SERIAL No.: 09/992,328

TITLE: "Drinking Container"

**PETITION TO (1) WITHDRAW RESTRICTION REQUIREMENT; (2)
REQUIRE REINSTATEMENT OF CLAIMS 2, 3, 6 AND 8-10 BASED ON THE
SUFFICIENCY OF THE DRAWINGS; AND (3) WITHDRAW NEW MATTER
REJECTIONS RELATED TO DRAWING AMENDMENTS AND TO REQUIRE
ENTRY OF APPLICANT'S FORMAL DRAWINGS**

FIG. 1A

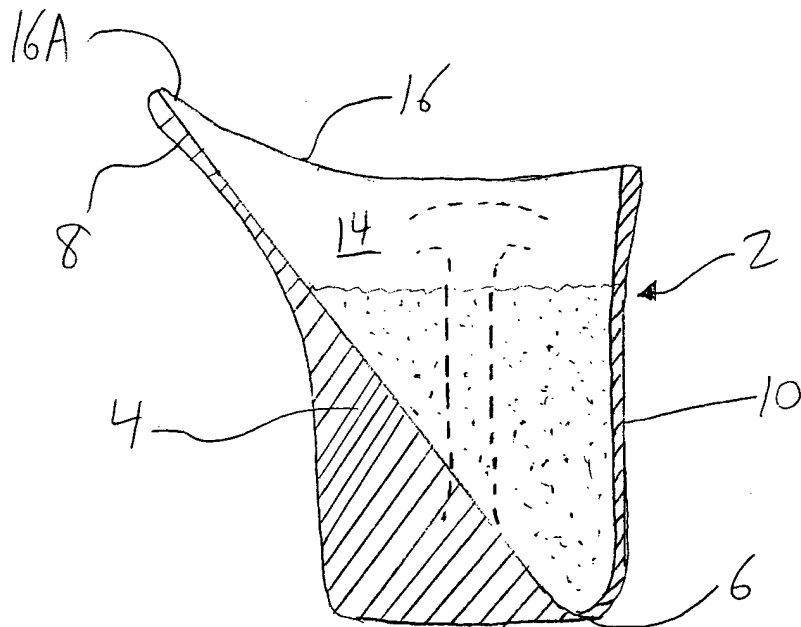
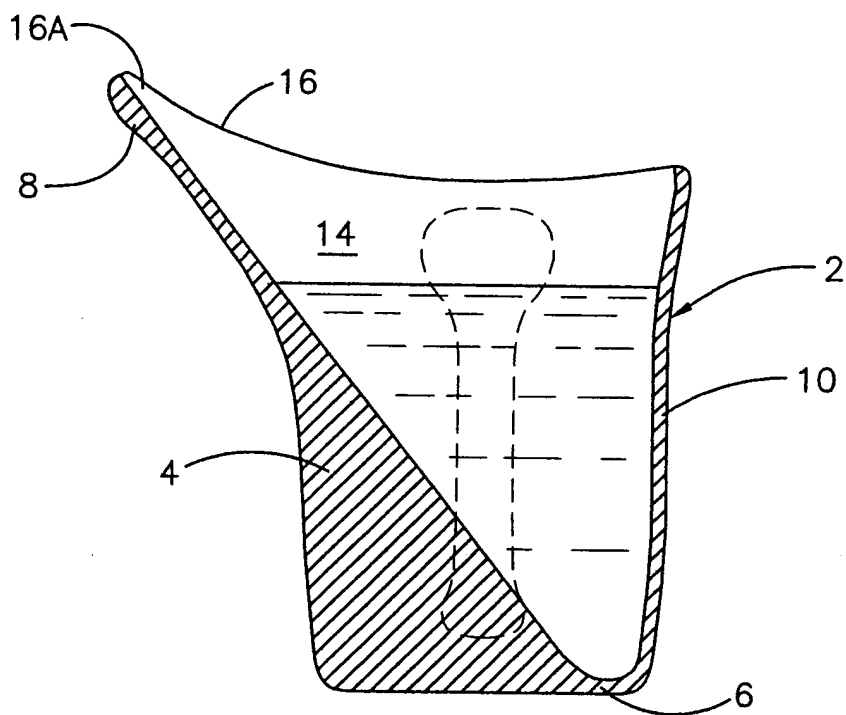
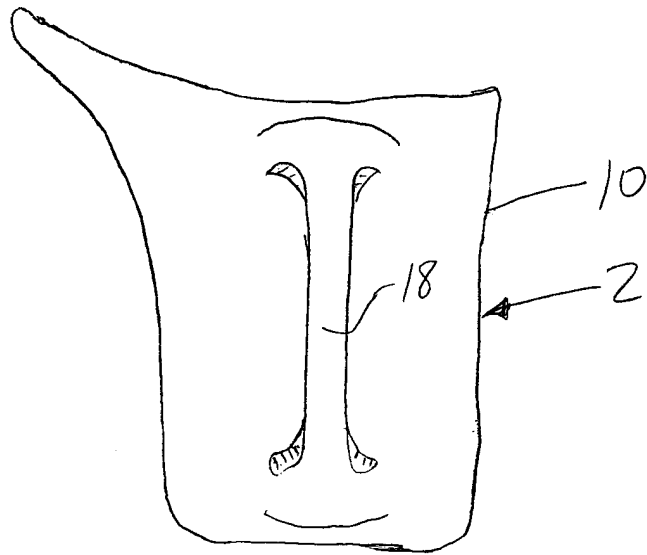
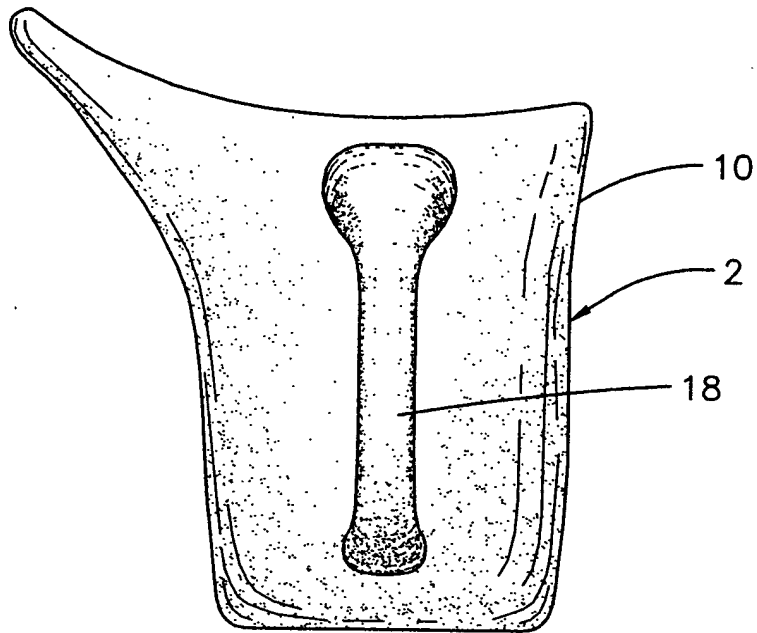
Examiner's statement	Applicant's response
"The original disclosure does not support	The handles shown in formal drawing

the showing of a different shaped handle as shown in Fig. 1A and 1B,” “	Figures 1A and 1B are not significantly different from the original draft drawing Figures 1A and 1C. Any differences are not patentable distinctions; they are merely minor design modifications that were made by the professional draftsman who applicant hired to prepare his formal drawings.
“a differently shaped bottom as shown in Fig. 1C,”	The bottom of the cup shown in formal drawing Figure 1C is not significantly different from the original draft drawing Figure 1C. Any differences are not patentable distinctions; they are merely minor changes in shape and proportion that were made by the professional draftsman who applicant hired to prepare his formal drawings.
“different creases as shown on the interior of the fluid diverter, flow channel and spout in Figure 2B and as shown on the exterior of Fig. 2A near spout 8, etc.”	<p>The items shown in applicant’s original draft drawings are not “creases.” They are representative markings that were intended to indicate the curvature or contour of the flow channel 12. The professional draftsman who prepared applicant’s formal drawings replaced the contour lines of the original drawing with stippling, a technique that is widely used to show contours in patent drawings.</p> <p>This curvature is clearly described in the specification at page 10, lines 4-5: “In the preferred embodiment shown in Figure 1C, the flow channel comprises a lengthwise groove formed by a pair of curved walls.”</p>

FIG. 1C

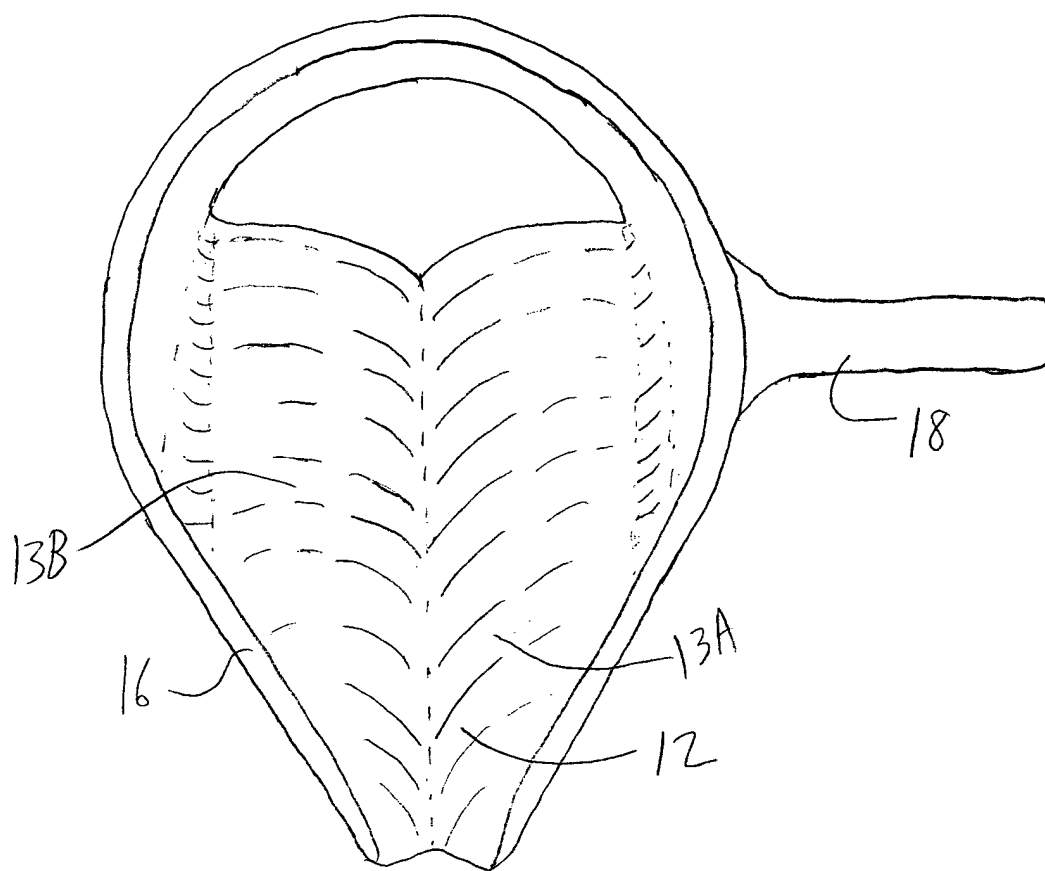
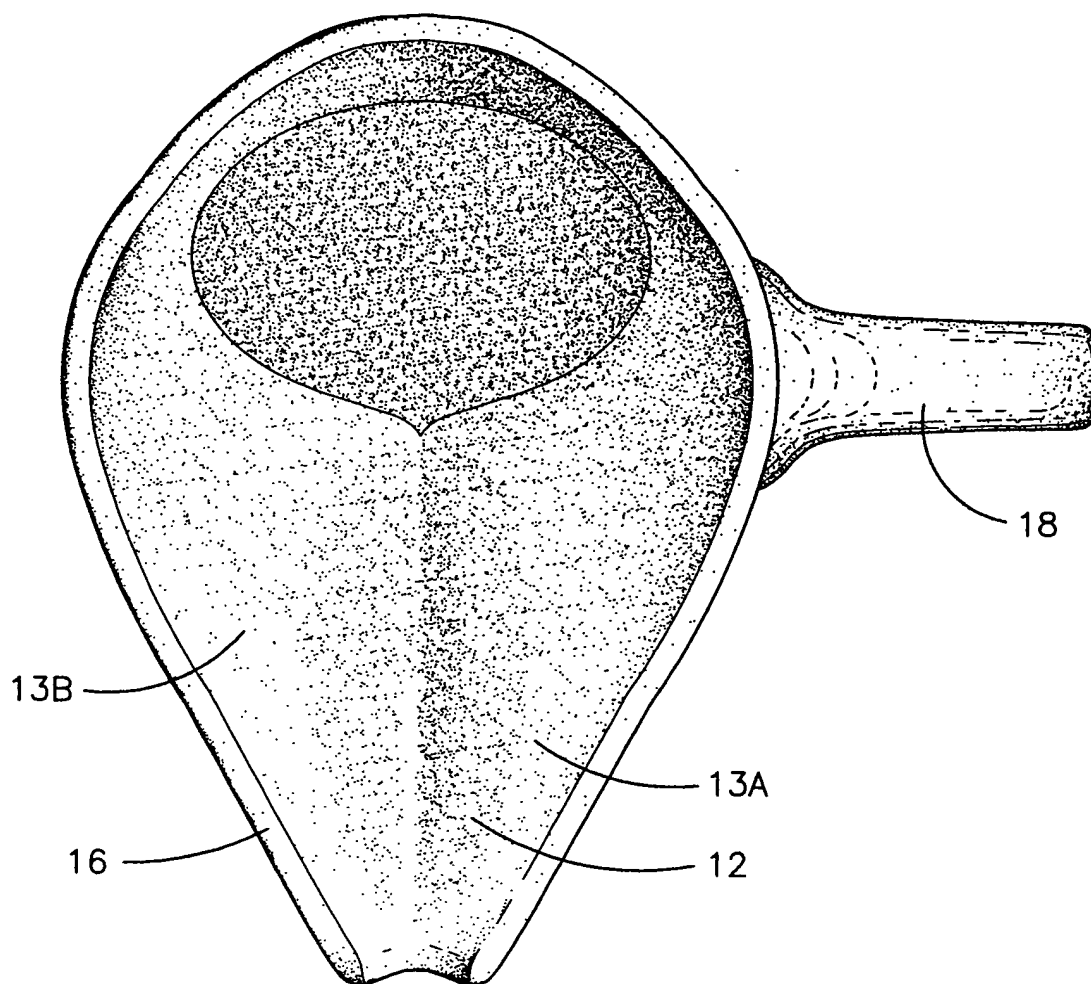
"do not show an extension spout extending upward and outward from the upper rim as claimed in claims 6 and 8-10 where the upper rim has an opening through at least a sipping region."	These items are clearly shown in Figures 1A, 1B, 1C, 2A, and 2B. The relationship and location of these items are described at page 10, lines 6-10: "The drinking container shown in Figure 1 includes an extension spout 8 extending upward and outward from the upper rim 16. The sipping region 16A is formed on the upper end of the extension spout 8. As shown in Figure 1, the extension spout 8 is contiguous with the fluid diverter member 4 to thereby assist the fluid diverter member 4 in compelling fluid through the sipping region 16A."
"The drawings are objected to under 37 CFR 1.83(a). The drawings must show every feature of the invention specified in the claims. Therefore, the flow channel extending lengthwise along an outer surface of the fluid diverter member as stated in claims 3 and 8-10 must be shown or the feature(s) canceled from the claims."	For the reasons set forth above, the flow channel is clearly shown in the drawings.

Fig. 2B

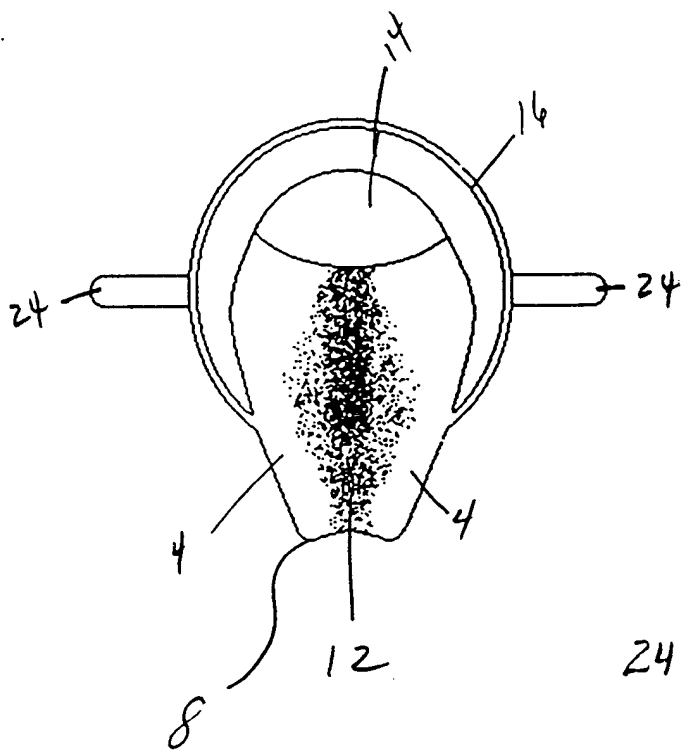
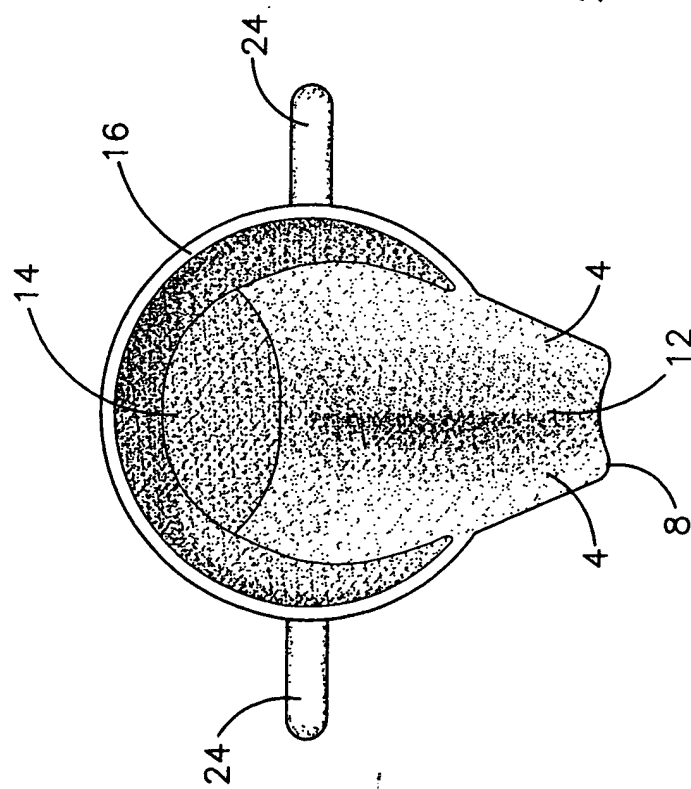
Examiner's statement concerning applicant's drawings	Applicant's response
"The fluid diverter 4, flow channel 12 and spout 8 are all located on substantially the same surface and these elements have no specific delineation to separate these elements as shown in Fig 2B."	Patent drawings routinely include a main component (here, the fluid diverter 4) that has subcomponents formed thereon (here, the flow channel 12 and the spout 8). The relationship of these three components to one another is clearly described at page 9, line 16 – page 10, line 10 of the specification. Applicant does not understand the basis of this objection, nor how it would be possible to comply with it.
"The elected specie of Fig. 2A and 2B do not show a wedge shaped fluid diverter as claimed in claims 2 and 8-10 . . ."	<p>The wedge shaped configuration of the fluid diverter member is shown in the cross-section view of Figure 1A. See specification p. 8, lines 14-15; see also Figures 3A and 4A. The top view shown in Figure 2B includes a fluid diverter member 4 that is wedge shaped.</p> <p>If the examiner is taking the position that due to applicant's election, figures other than Figs. 2A and 2B cannot be relied upon as showing claimed features,</p>
